Hornsea Project Three Offshore Wind Farm

Applicant Responses to the ExA's Further Information – Rule 17

Date: 26th March 2019

Hornsea Three
Spirit Energy Protective Provisions
(REP7-093)

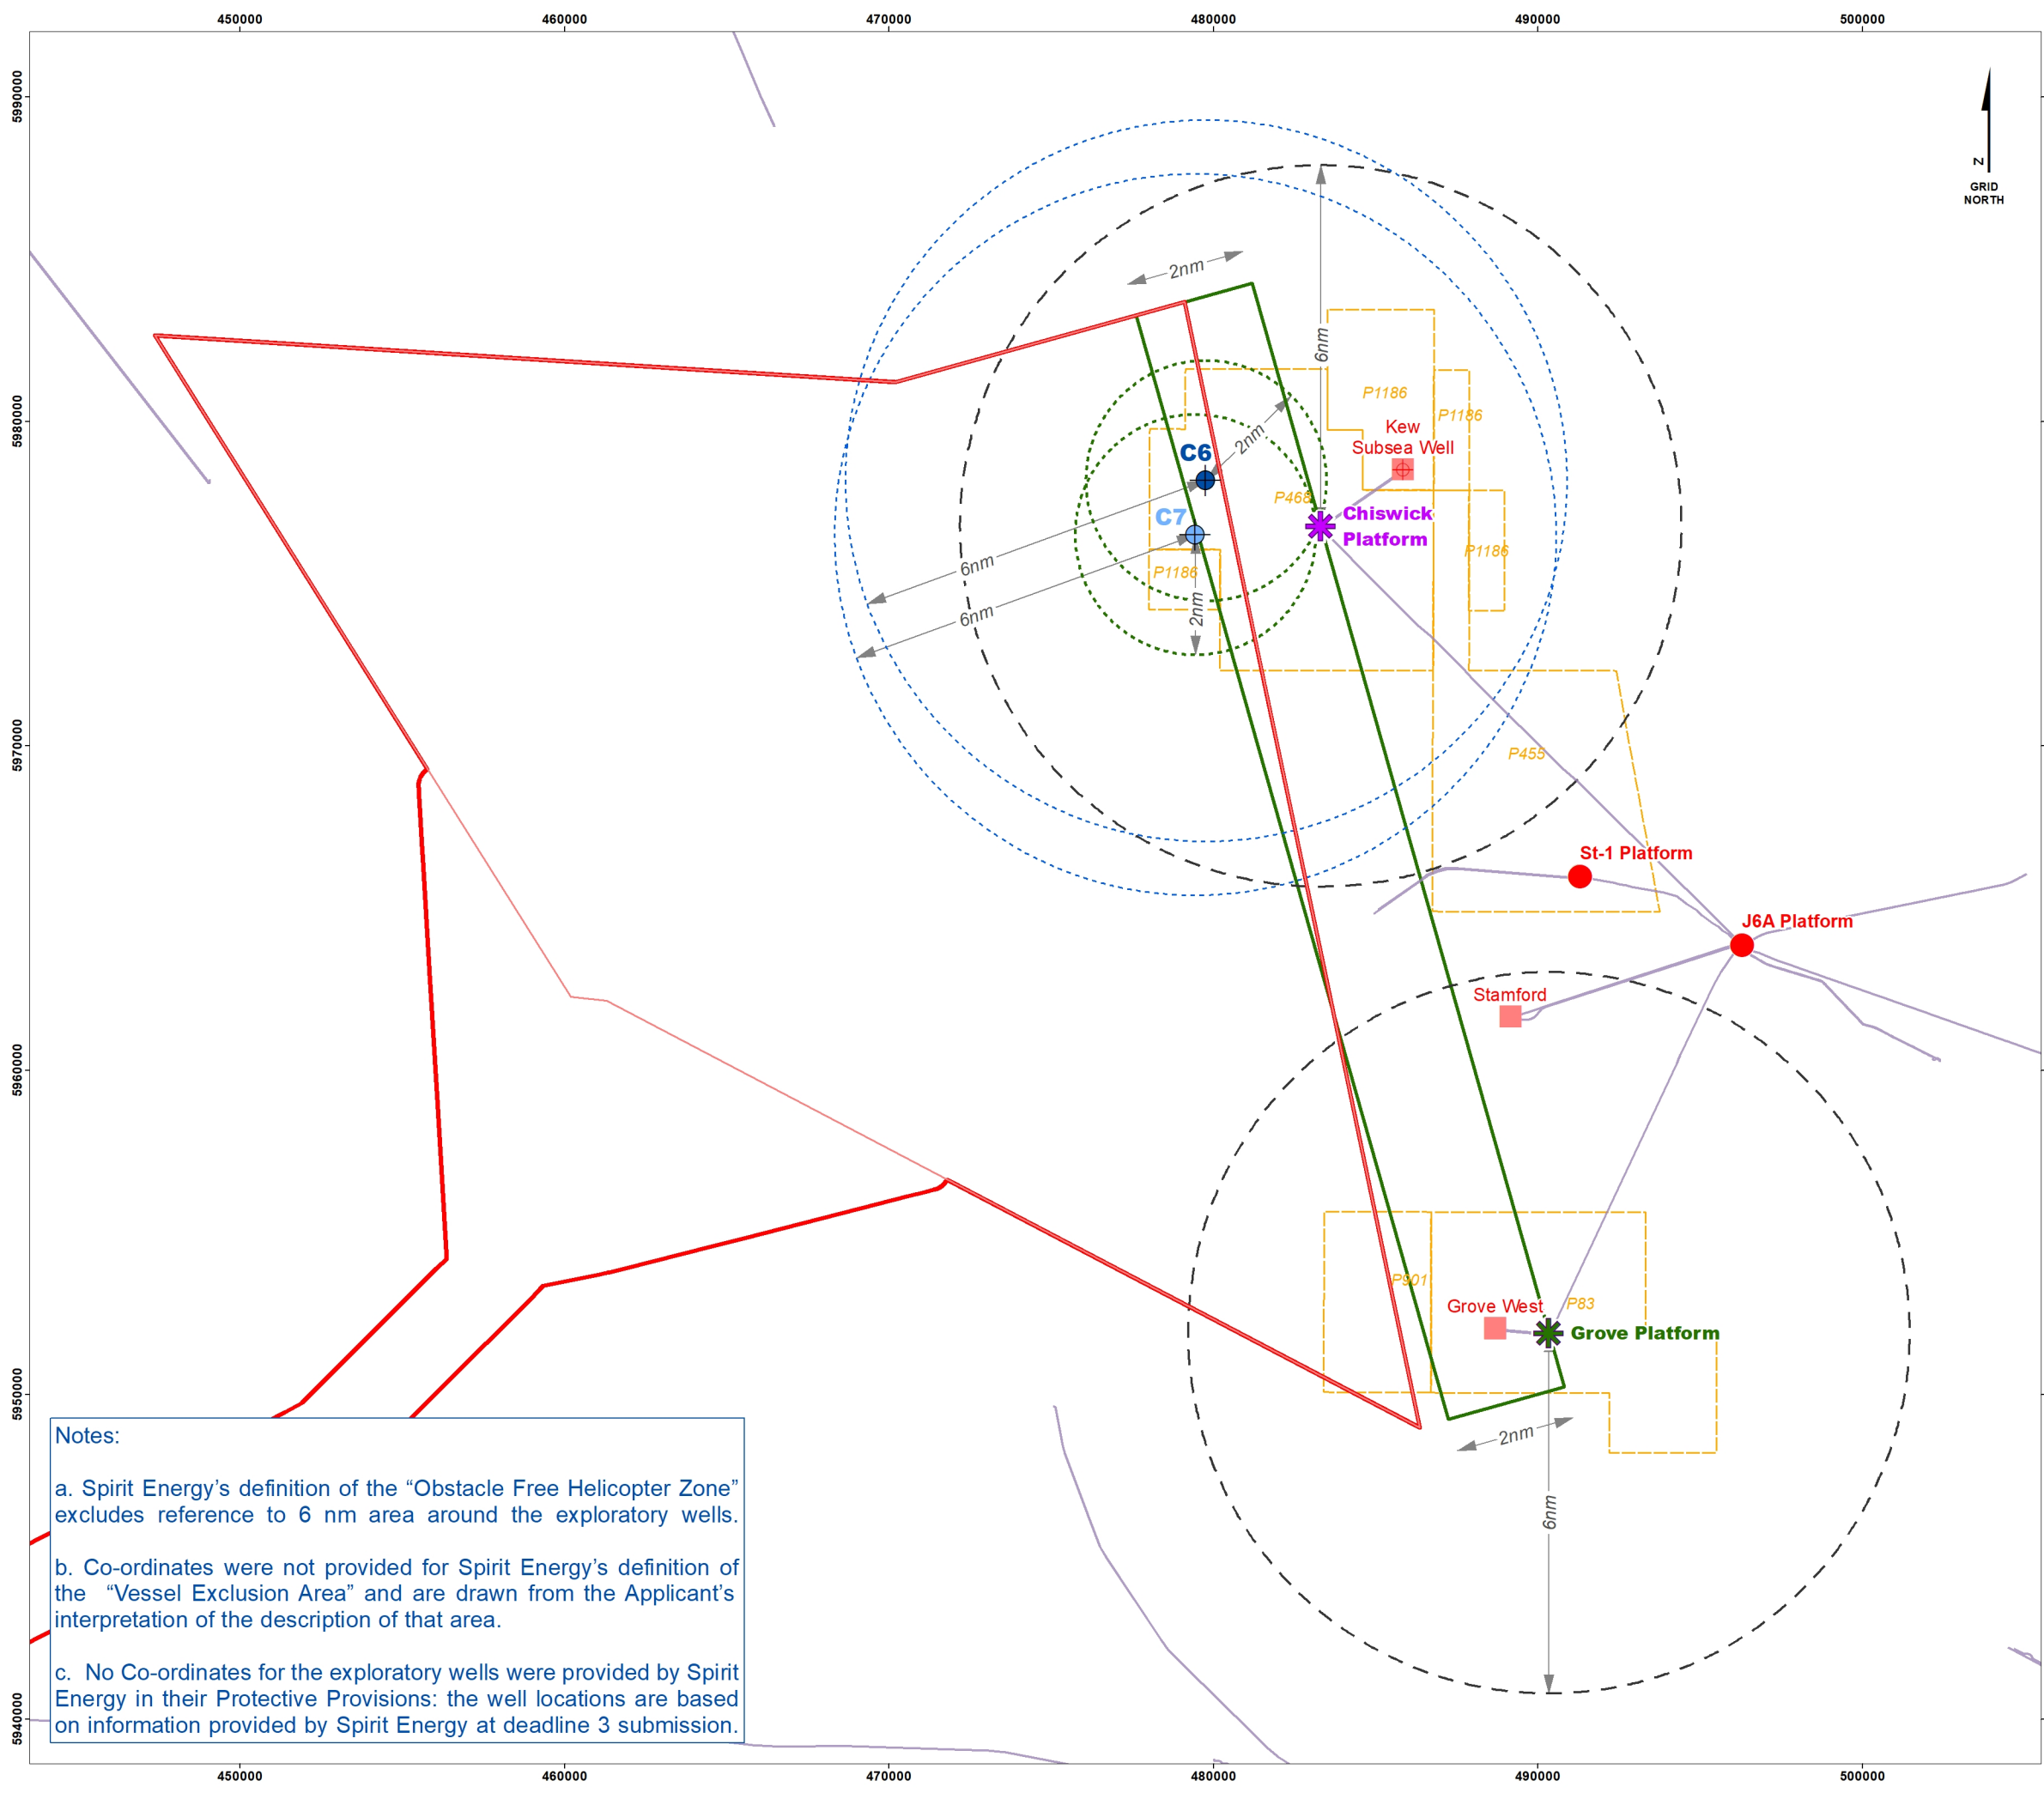
PINS Ref. No.	Question is addressed to:	ExA Question	Draft Response
F3.6	Applicant	<p>Spirit Energy has proposed protective provisions which may restrict the ability to construct wind turbine generators in parts of the Order limits [REP7-093].</p> <p>Please provide plans showing the effect of the suggested provisions in relation to the proposed Order limits.</p> <p>Please comment on the likely effects on the number of wind turbine generators that could be constructed and on the generation capacity of the Proposed Development for each of the following scenarios.</p> <p>The scenarios are that the Secretary of State decides to impose:</p> <ol style="list-style-type: none"> The suggested obstacle-free helicopter flight volume (but not the suggested vessel exclusion area) The suggested vessel exclusion area (but not the suggested obstacle-free helicopter flight volume) The suggested obstacle-free helicopter flight volume and the suggested vessel exclusion area 	<p>The Applicant has provided plans illustrating both parties' protective provisions in relation to the Order limits in Annexes 1 and 2 of this document. Annex 1 shows the Protective Provisions submitted by Spirit Energy at deadline 7 (REP7-093) (as interpreted by the Applicant in absence of a plan being provided by Spirit Energy) which include:</p> <ol style="list-style-type: none"> An Obstacle Free Helicopter Zone comprising a radius of 6 nm extending from the centre points of the Chiswick and Grove helidecks, respectively, A Vessel Exclusion Area <i>"means in so far as relevant, the volumes extending from the sea surface at mean sea level down to the sea bed (i) bounded to the east by a notional loxodrome drawn through and extending beyond the centres of the Chiswick and Grove Platforms, to the west by a loxodrome parallel to that loxodrome and at all times 2 nm to the east of it, to the north by the loxodrome of latitude passing through the northernmost point on the perimeter of the windfarm array, to the south by the loxodrome of latitude passing through the southernmost point on the perimeter of the windfarm array and (ii) bounded by a circle of radius of 2 nautical miles centred on the centre point of each of the Relevant Sub-Sea Well Heads."</i> Although not captured in the definition of the Obstacle Free Helicopter Zone Spirit Energy state that the, <i>"Protective Provision still reflects the continuing need for helicopters to be able to operate under a variety of weather conditions to and from the NUIs and rigs or vessels over subsea infrastructure, whereby any wind turbines will require to be offset from the NUIs and C6 and C7 by at least 6nm"</i> (REP7-093). As such, the Applicant has included a radius of 6nm extending from each of the speculative C6 & C7 wells (based on interpreted well locations in absence of confirmation of actual well locations being provided by Spirit Energy) in the plan and this has been considered as a separate likely effects scenario.

<p>Spirit Energy's Protective Provisions' likely effects on the number of wind turbine generators that could be constructed and on the generation capacity of the Proposed Development are provided under the following scenarios and are based on indicative layouts A and B provided in the Project Description chapter of the Environmental Statement (ES) (APP-058). The Applicant has estimated the likely effects on the number of wind turbine generators (WTGs) and on the generation capacity of the Proposed Development, assuming the indicative positions given in Layout A. The Applicant has also assumed, for the purposes of this question, the use of a WTG with a nameplate capacity of 8MW. Given these assumptions, the impacts of implementing the protective provisions proposed by Spirit Energy are given below. It should be noted that these effects may vary based on the outcome of detailed design and especially the choice of WTG and are presented here as indicative impacts only. The figures presented for the generation capacity are also approximate and assume that the total generation capacity of the wind farm, without any restrictions on areas of construction, would be approximately 2400MW.</p> <p>Notwithstanding these indicative impacts – the Applicant considers that due weight can be applied by the ExA. The likely effects on the number of WTGs that could be constructed and on the generation capacity of the Proposed Development for each of the scenarios described below is presented in Table 1.1 and as follows:</p> <p>a) The suggested obstacle-free helicopter flight volume (but not the suggested vessel exclusion area):</p> <p>Given the inconsistent wording of the Protected Provisions provided by Spirit Energy in their post-hearing submission at deadline 7 (D7-093) the Applicant has interpreted this scenario in two ways.</p> <p><u>Scenario 1.</u> Implementation of 6nm buffers around the existing platforms, <u>but not</u> the proposed wells: This scenario would lead to a reduction in the array area of 168 km², which would correspond to 24% of the array area being unusable for WTG construction.</p> <p>Noting the above assumptions, i.e. an 8MW WTG and indicative layouts A (or B) this is likely to limit the generation capacity <u>to</u> approximately 1820MW.</p>

<p><u>Scenario 2.</u> Implementation of 6nm buffers around the existing platforms <u>and</u> the proposed wells: This scenario would lead to a reduction in the array area of 233 km², which would correspond to 33% of the array area being unusable for WTG construction. Noting the same assumptions used under (a), i.e. an 8MW WTG and indicative layouts A (or B), this is likely to limit the generation capacity to approximately 1590MW.</p> <p><u>b) The suggested Vessel Exclusion Area (alone) with (Scenario 3(i)) and without (Scenario 3(ii)) the 2 nm buffer around speculative wells</u></p> <p><u>Scenario 3i.</u> This scenario would lead to a reduction in the array area of 17 km², which would correspond to 2% of the array area being unusable for WTG construction. With the above assumptions, this is likely to limit the generation capacity to approximately 2340MW.</p> <p><u>Scenario 3ii:</u> This scenario would lead to a reduction in the array area of 43 km², which would correspond to 6% of the array area being unusable for WTG construction. With the above assumptions, this is likely to limit the generation capacity to approximately 2230MW.</p> <p><u>c) The suggested obstacle-free helicopter flight volume and the suggested vessel exclusion area</u></p> <p>This in combination effect of the scenarios 1 and 2 set out above under (a) with scenario 3 in (b):</p> <p><u>Scenario 1, plus 3:</u> Reduction in the array area of 186 km², which would correspond to 26% of the array area being unusable for WTG construction. Generation capacity limited to approximately 1760MW.</p> <p><u>Scenario 2 plus 3.</u> Reduction in the array area of 250 km², which would correspond to 36% of the array area being unusable for WTG construction. With the above assumptions, this is likely to limit the generation capacity to approximately 1530MW.</p>

Hornsea Three
Spirit Energy Chiswick and Grove Assets
(REP7-055)

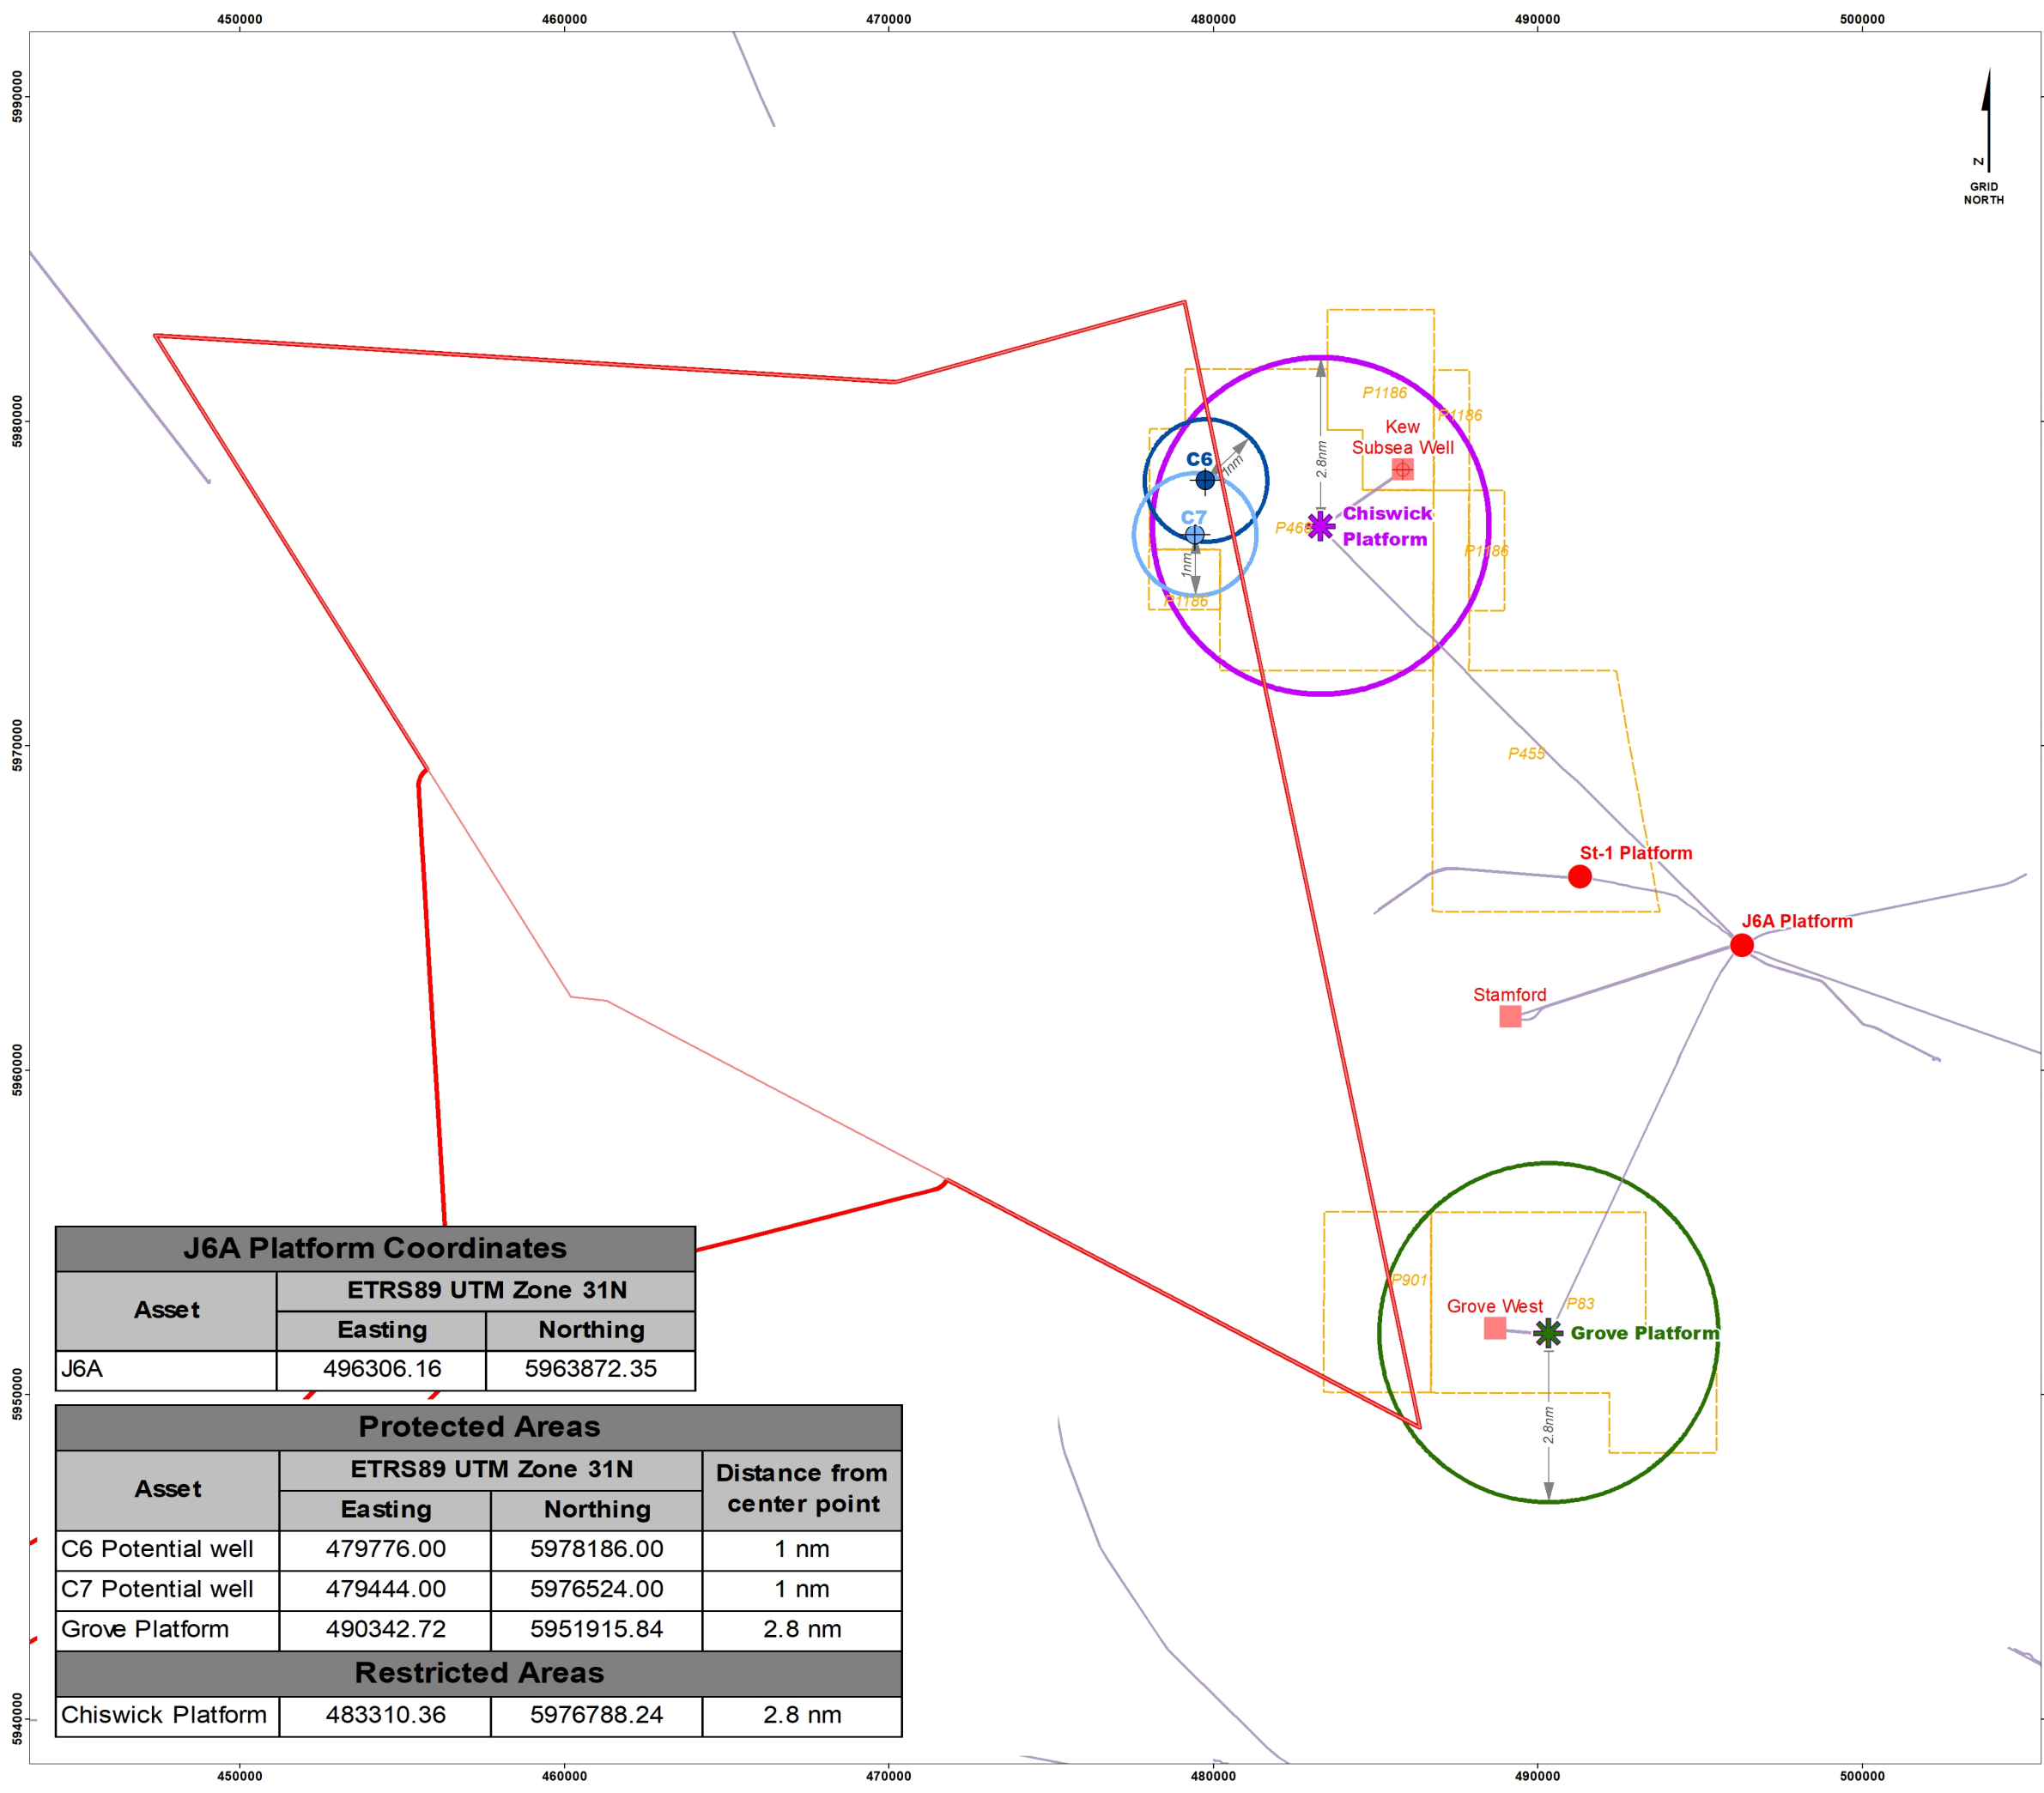
PINS Ref. No.	Question is addressed to:	ExA Question	Draft Response
F3.7	Applicant	<p>You have suggested protective provisions for Spirit Energy [REP7-055].</p> <p>Please comment on the likely effects on the number of wind turbine generators that could be constructed and on the generation capacity of the Proposed Development if your suggested protective provisions were adopted.</p>	<p>The Applicants plan showing its protective provisions was provided in Appendix 36 at Deadline 7 (REP7-055) and is included in Annex II. The Applicants protective provisions comprise:</p> <ol style="list-style-type: none"> 1. A restricted zone extending in a 2.8 nm radius from the Chiswick Platform 2. A protected area extending in a 2.8 nm radius from the Grove Platform 3. Protected areas extending in a 1 nm radius from each of the speculative C6 and C7 wells. <p>The same assumptions applied for evaluating Spirit Energy Provisions are used to evaluate the likely effects of the Applicants provisions. The likely effects on the number of WTGs that could be constructed and on the generation capacity of the Proposed Development for each of the scenarios described below is presented in Table 2.1 and as follows.</p> <p>a) The 2.8 nm restricted area around Chiswick Platform</p> <p><u>Scenario 1:</u> This scenario would lead to a reduction in the array area of 16 km², which would correspond to 2% of the array area being unusable for WTG construction. With the above assumptions, this is likely to limit the generation capacity to approximately 2340MW.</p> <p>b) The 2.8 nm restricted area around Chiswick Platform and 2.8 nm protected area around Grove Platform</p> <p><u>Scenario 2:</u> 2.8nm restricted area around Chiswick and Grove Platforms: This scenario would lead to a reduction in the array area of 18 km², which would correspond to 3% of the array area being unusable for WTG construction. With the above assumptions, this is likely to limit the generation capacity to approximately 2330MW.</p> <p>3) The 2.8 nm restricted area around Chiswick Platform, 2.8 nm area around Grove Platform and 1 nm buffer areas around speculative C6 & C7 wells.</p> <p><u>Scenario 3:</u> 2.8nm restricted area around Chiswick and Grove Platforms and 1nm buffer around speculative wells C6 and C7. This scenario would lead to a reduction in the array area of 20 km², which would correspond to 3% of the array area being</p>

<p>unusable for WTG construction. With the above assumptions, this is likely to limit the generation capacity to approximately 2320MW.</p>
--	--	--	--
